POOL BARRIER PLAN

Project:	PROPOSED POOL, SPA & ALFRESCO
Client:	CANN
Site:	35 KEEL RETREAT, PORT GEOGRAPHE

Sheet title	**POOL BARRIER PLAN**
Date	21 Oct 2026
Revision	A
Scale	1:100

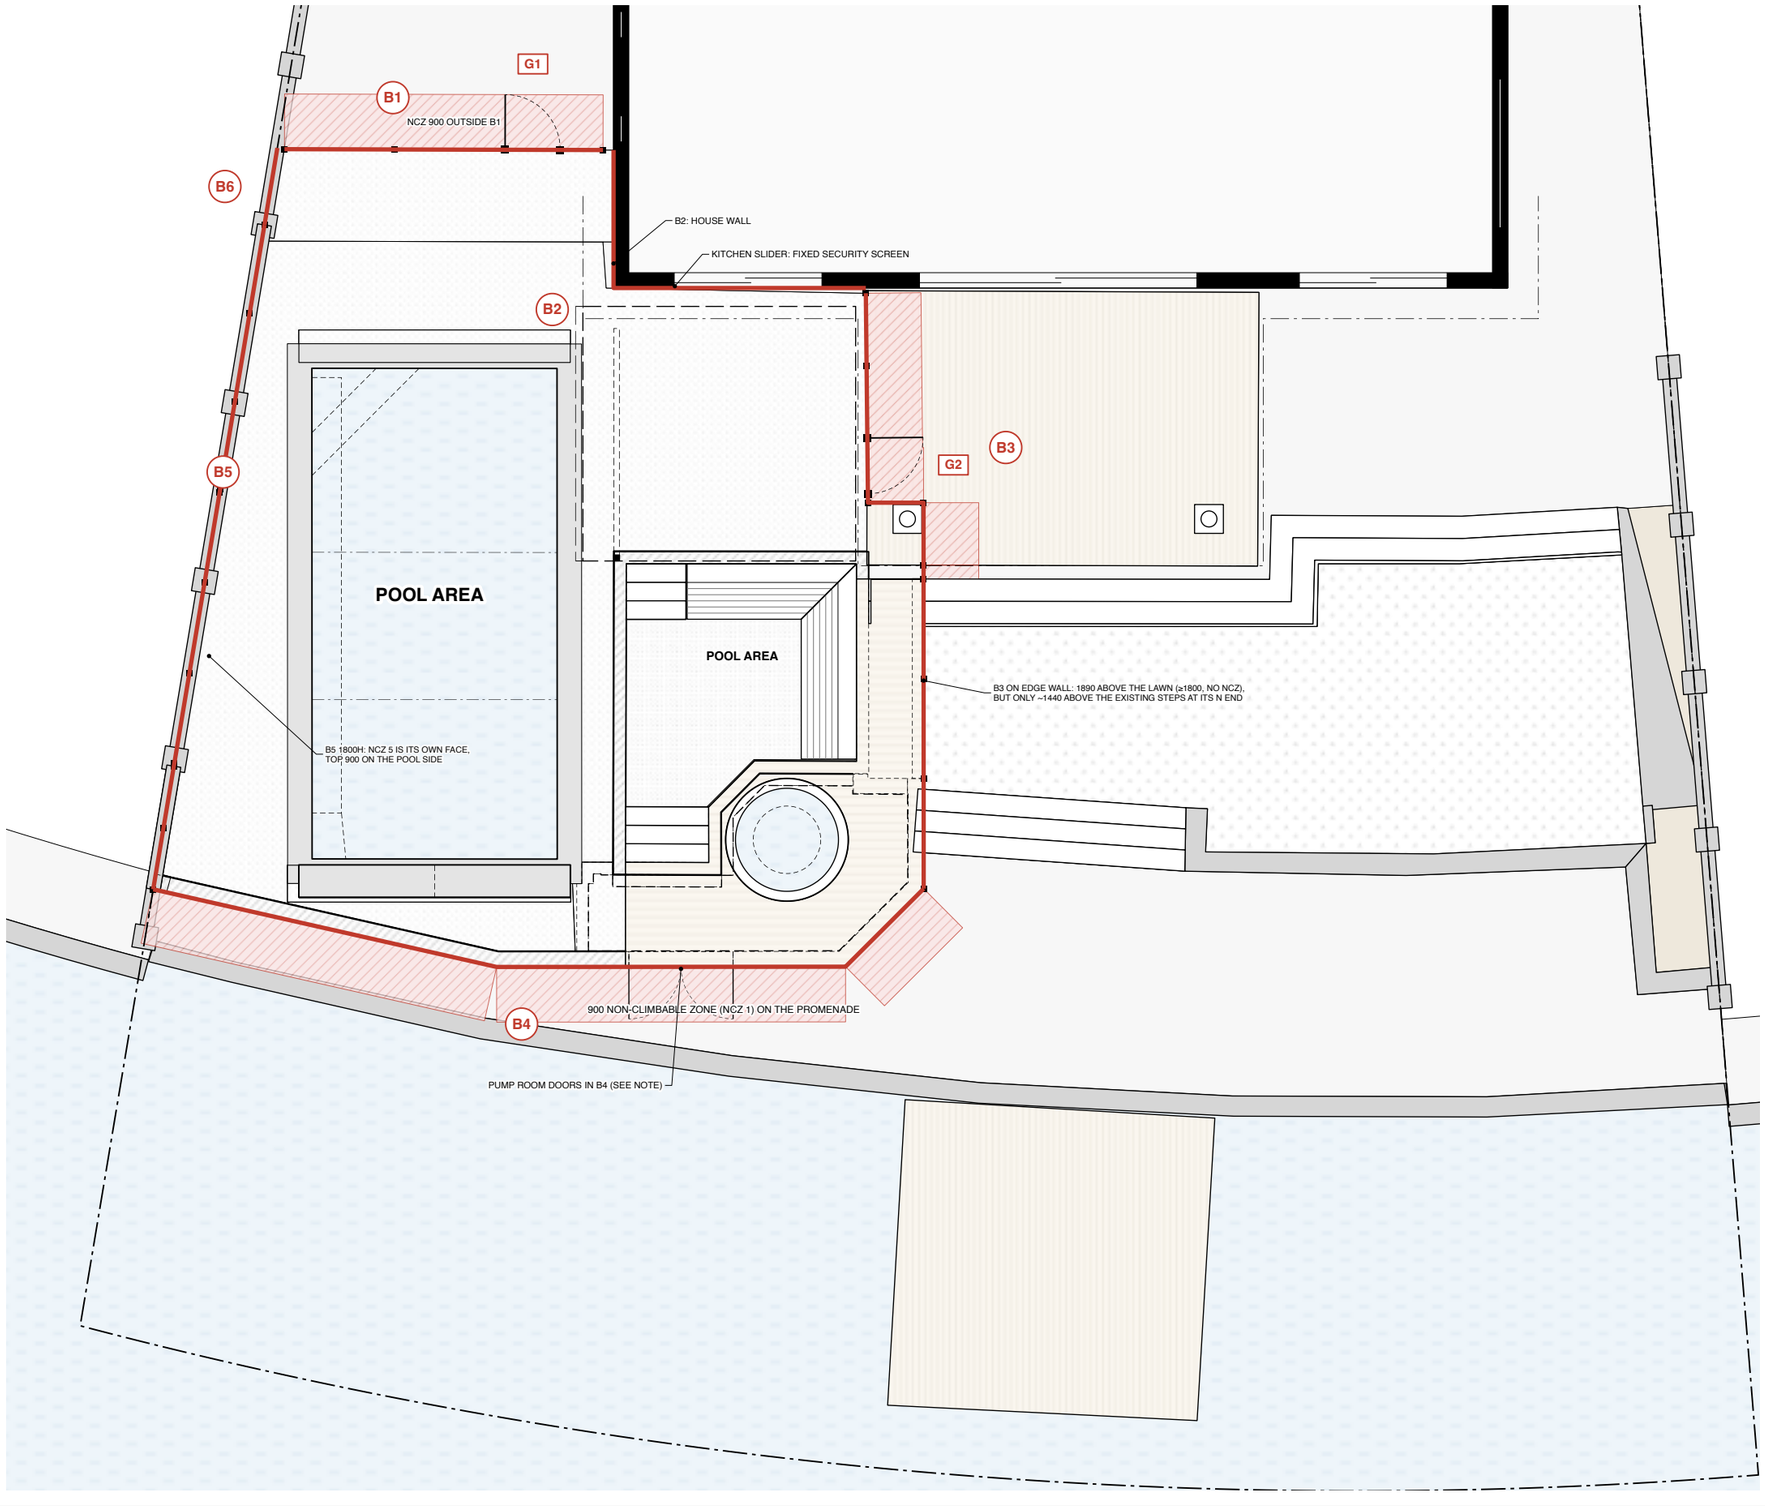
- B3 at its north end: only about 1440 above the existing lawn steps against it. OK as is?
- Pump room doors in B4, the canal-side barrier wall: their outside face must be non-climbable. Which door and finish?
- B1 and B3 stop 170 and 90 short of the house wall: close them up.
